ADDENDUM # 1

Quechee State Park – Upgrades

Date: October 21, 2021

A - 1

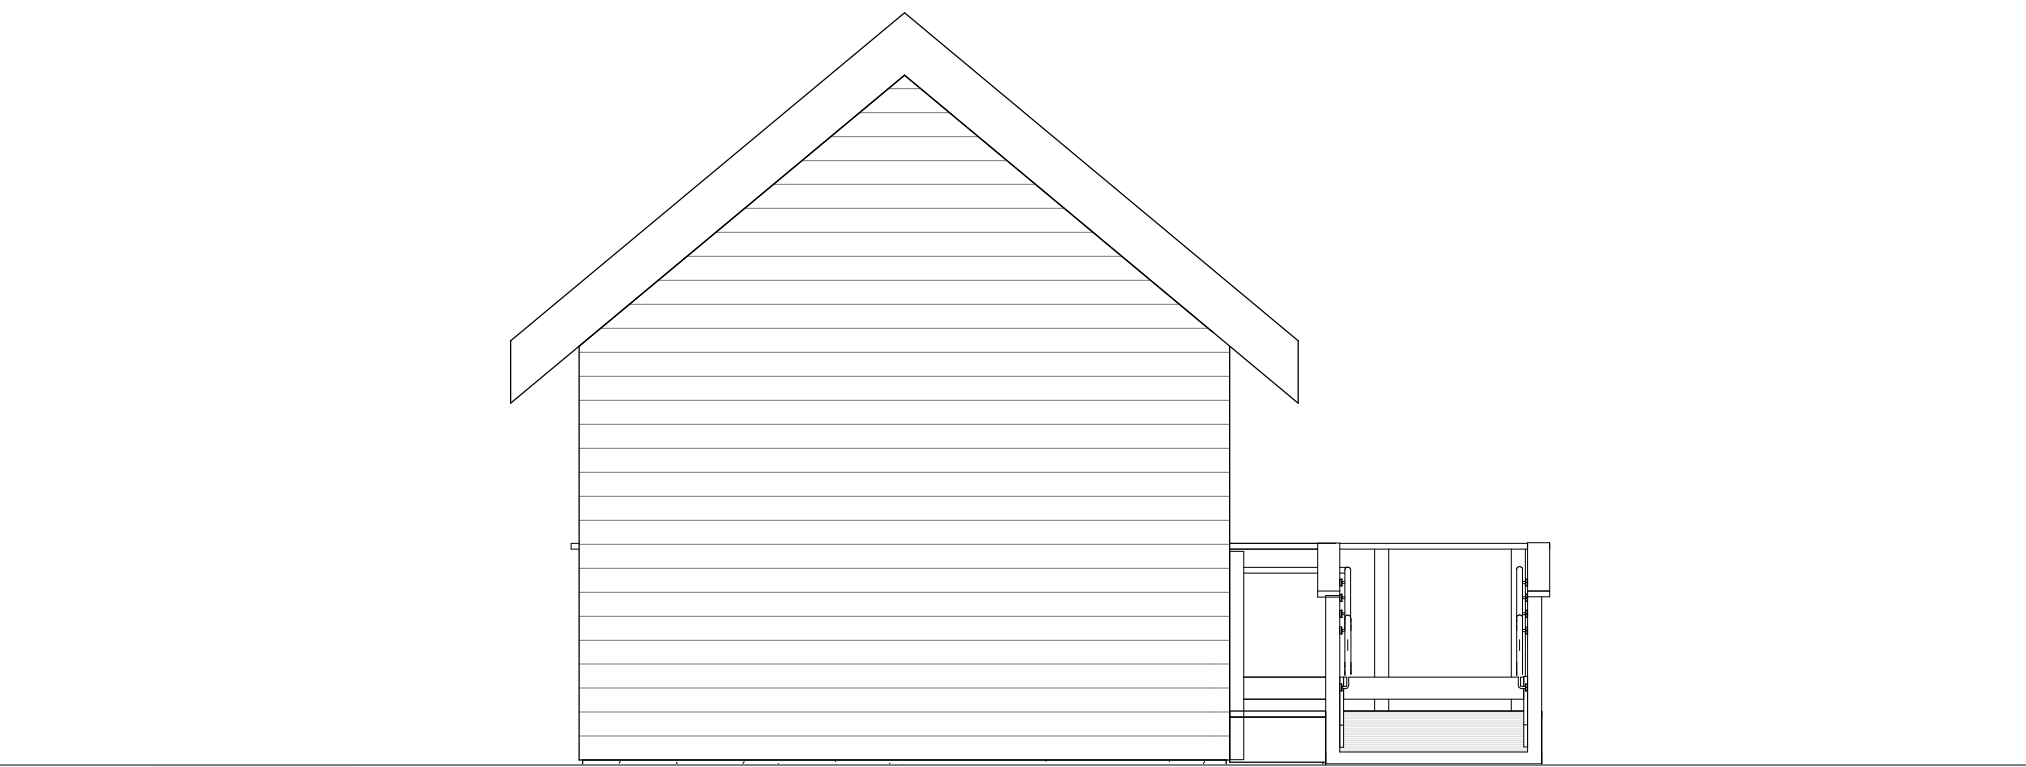
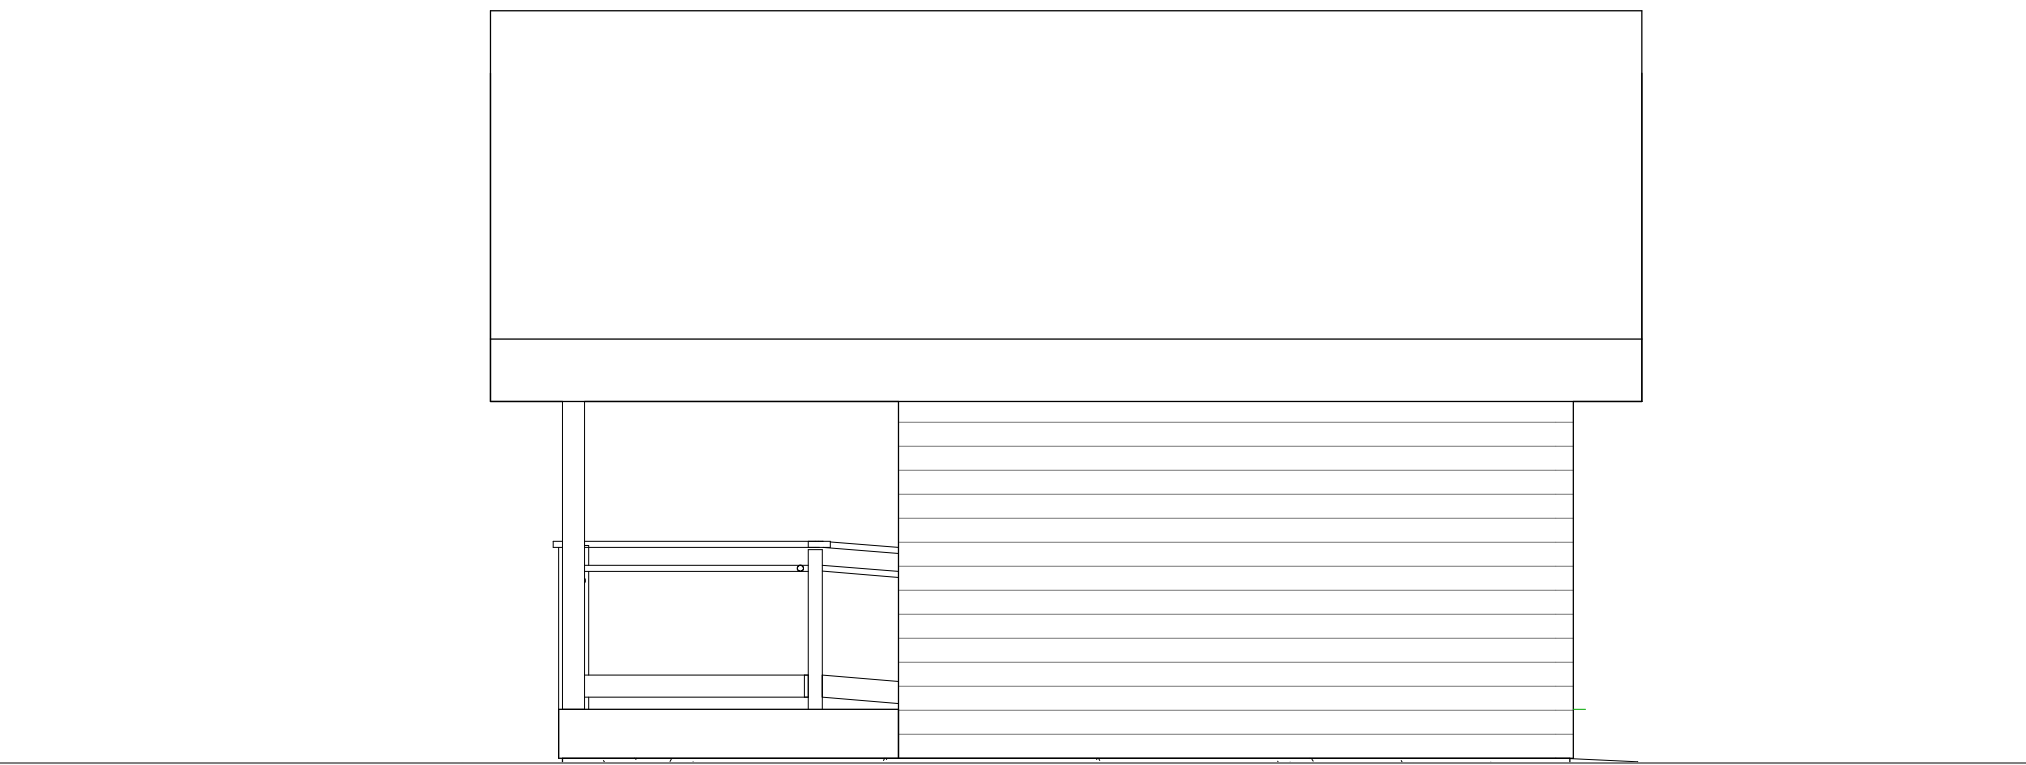
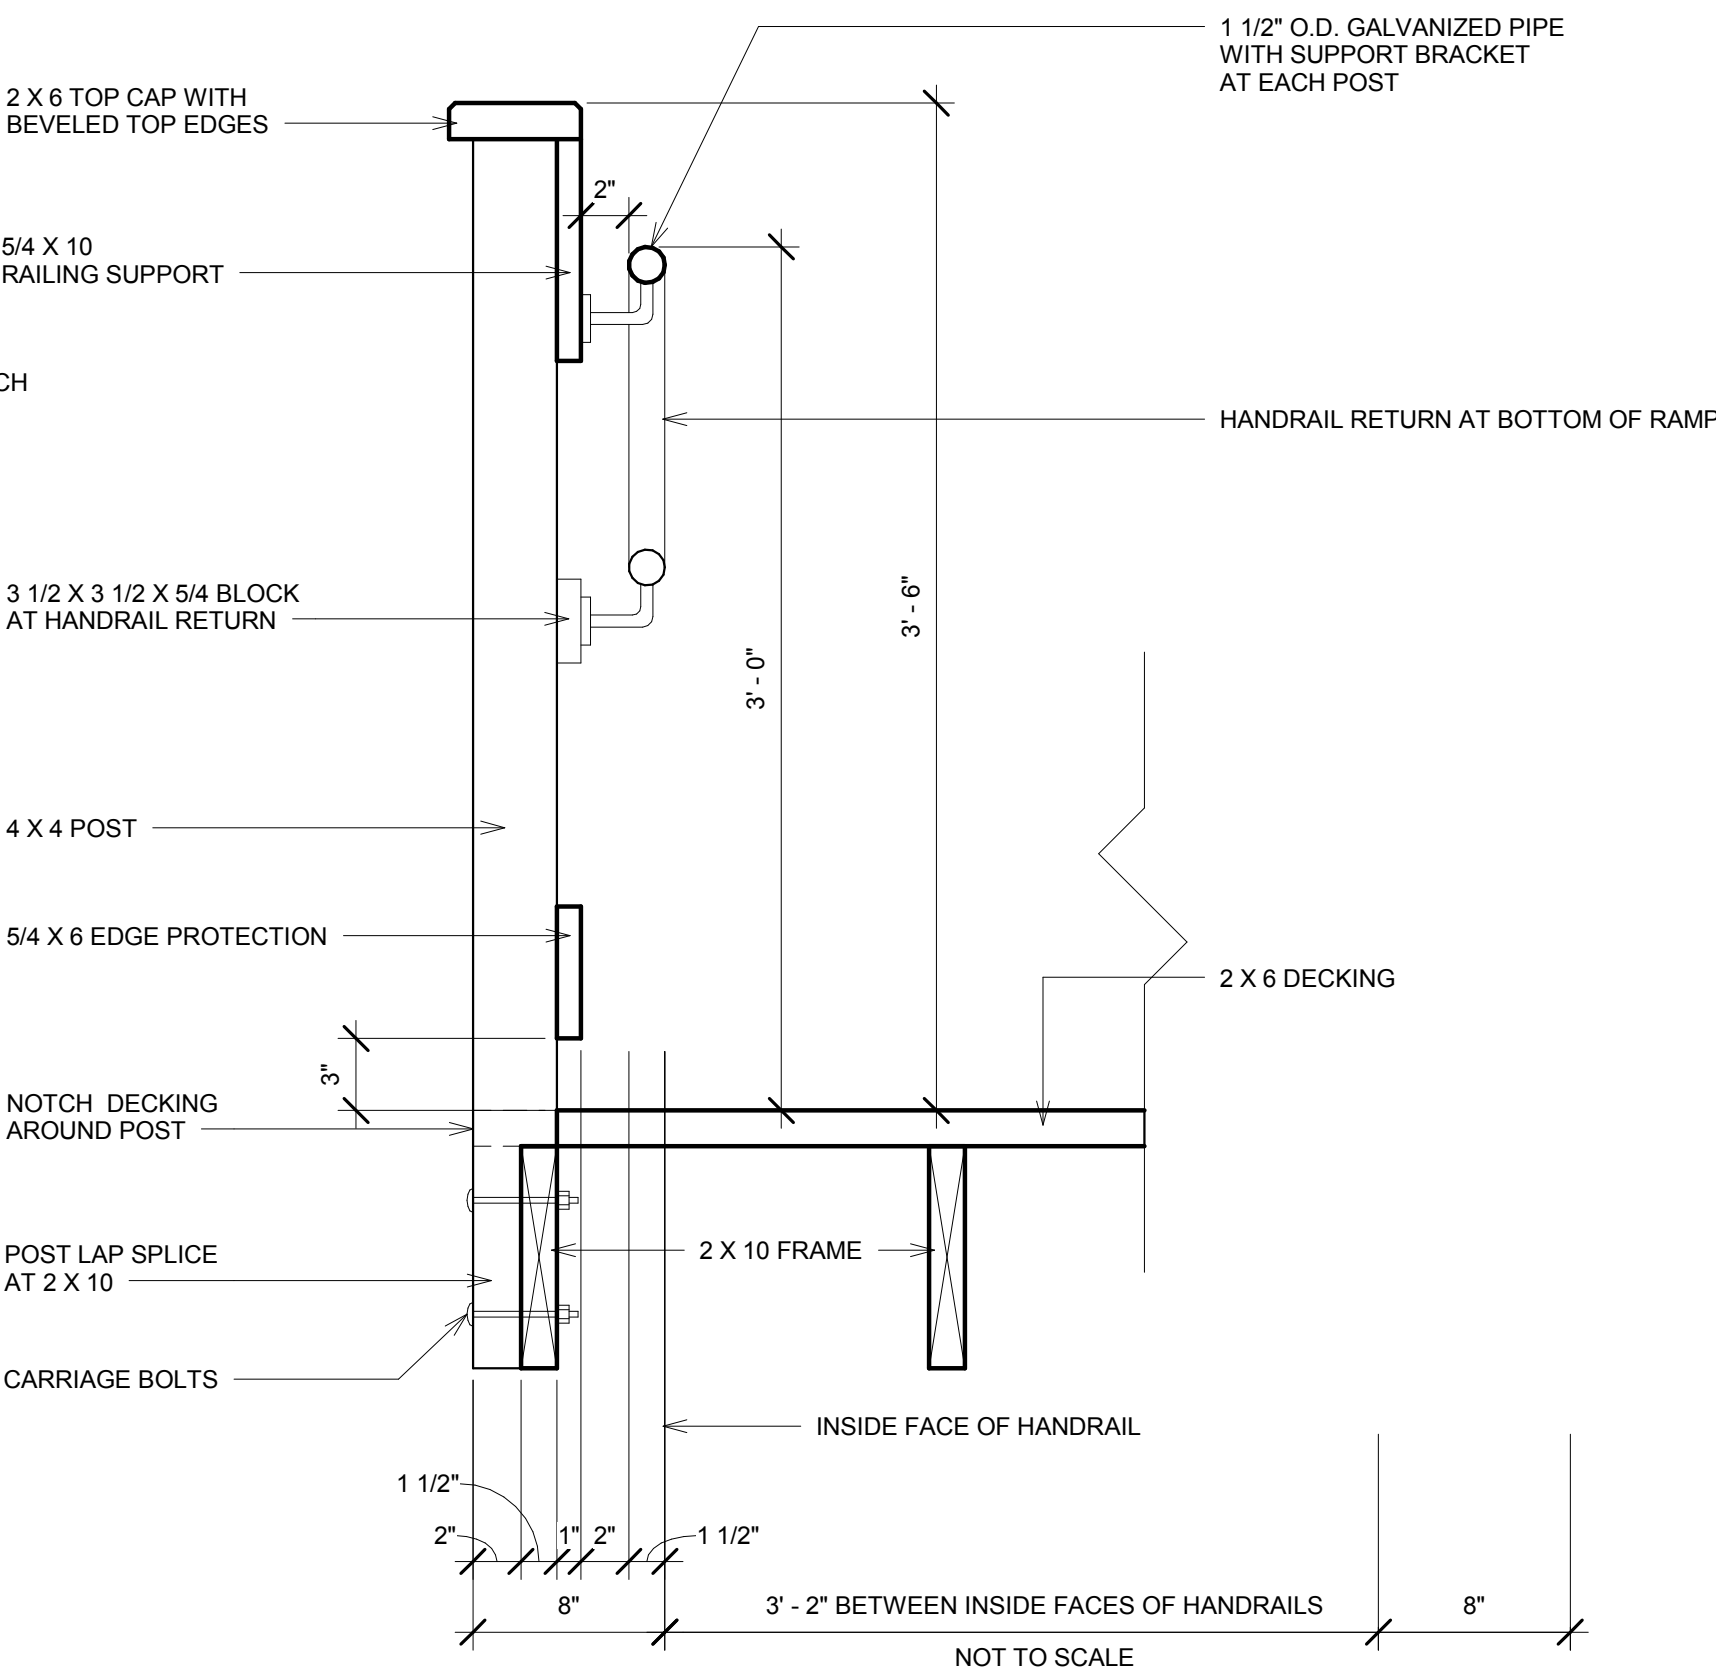
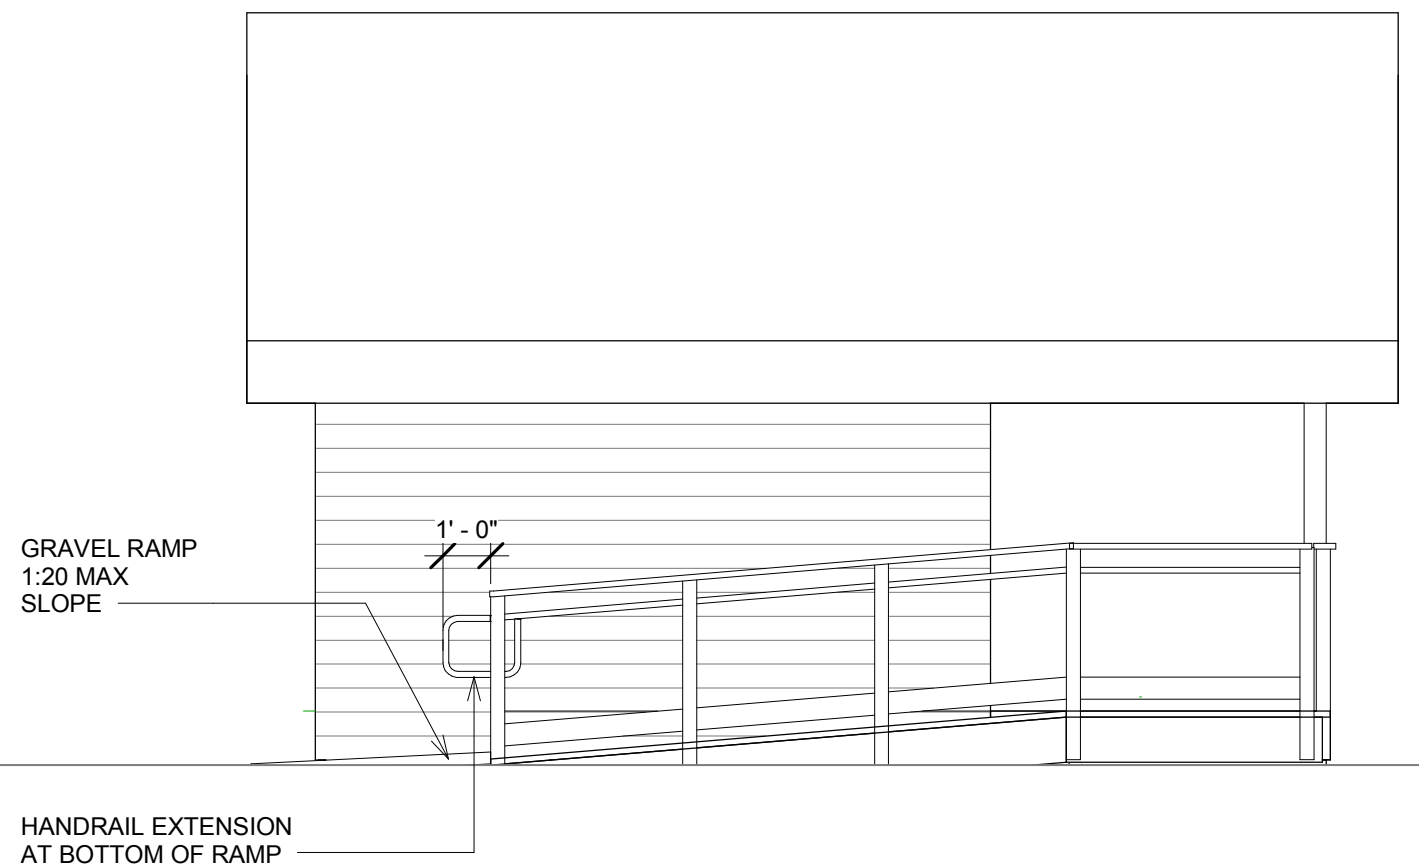
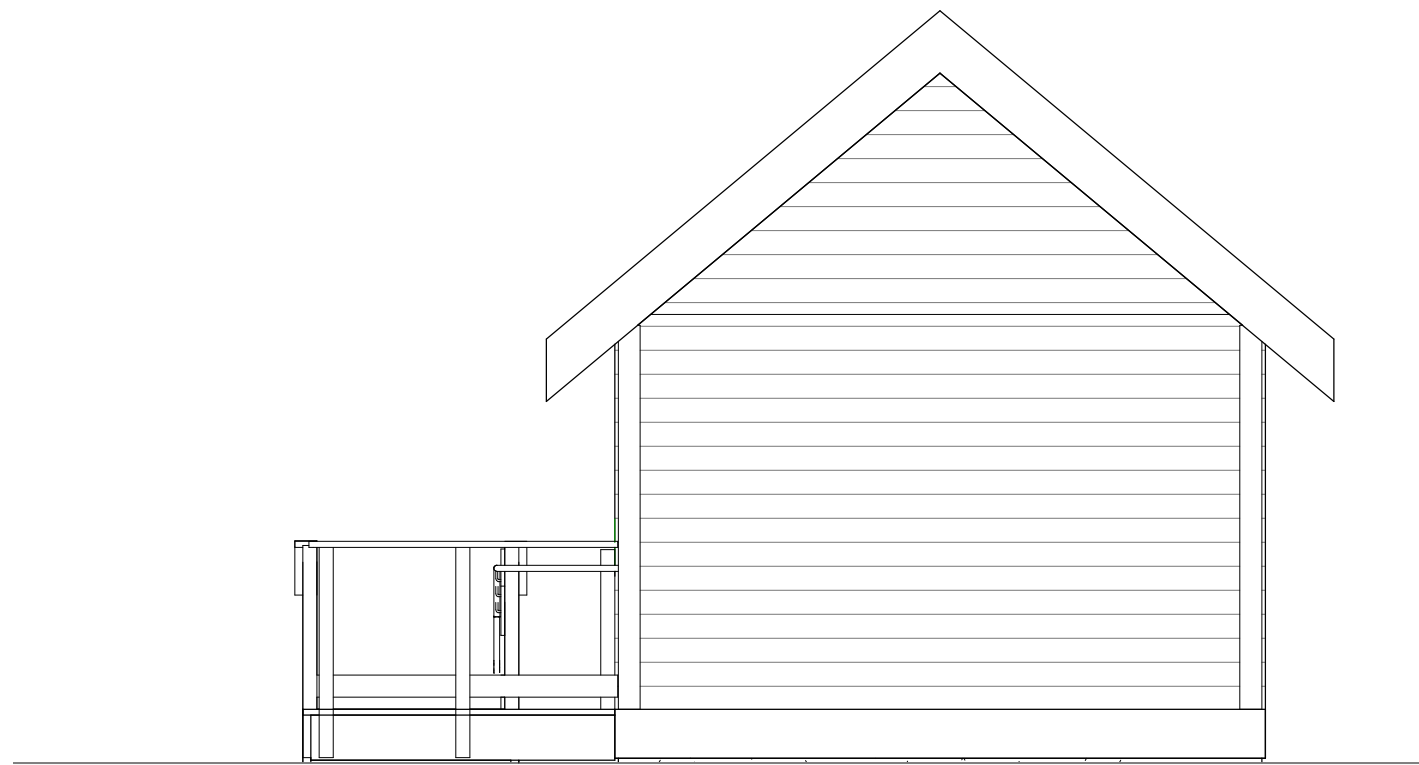
- Please see additional Cabin Ramp plans, two sheets numbered A1 & A2 by Cole Engineering & Construction. These were mistakenly omitted from the original bid set. All six cabins will have an ADA accessible ramp joining the front porch. There are two ramp options shown and which option will be determined in the field for each cabin. Please provide a price for each type of ramp - Add/Alternate #1 for Ramp Type #1 and Add/Alternate #2 for Ramp Type #2.
